Response to Bournemouth Airport

Aircraft noise over Brockenhurst and compliance with AD 2.21

From the Brockenhurst Community Action Group. Prepared from the aircraft's own broadcast GPS data (ADS-B), 2023 to 2025, via the public OPDI and OpenSky datasets. Every figure is independently reproducible. All counts are minimums.

Bournemouth arrivals over Brockenhurst: breaches the radar-vectoring defence does not explain

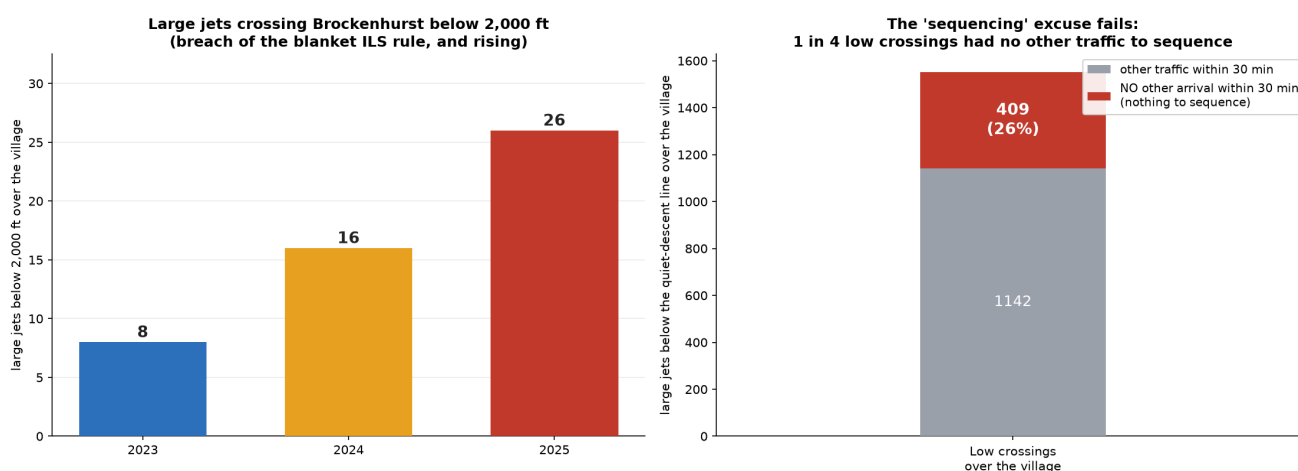
Your response states that aircraft "may be tactically descended, levelled or sequenced ... as part of the safe and orderly management of traffic." Sequencing requires other traffic to sequence against. We tested this against the arrival record:

- Of the large jets crossing the village **below the continuous-descent height, 26% (409 flights) had no other arrival within 30 minutes**, and 45% had none within 15 minutes.
- **117 low night crossings had no other arrival within 30 minutes.**

A single aircraft brought to 1,600 ft over a National Park village at night, with no other traffic in the sky, cannot be explained as the orderly management of traffic.
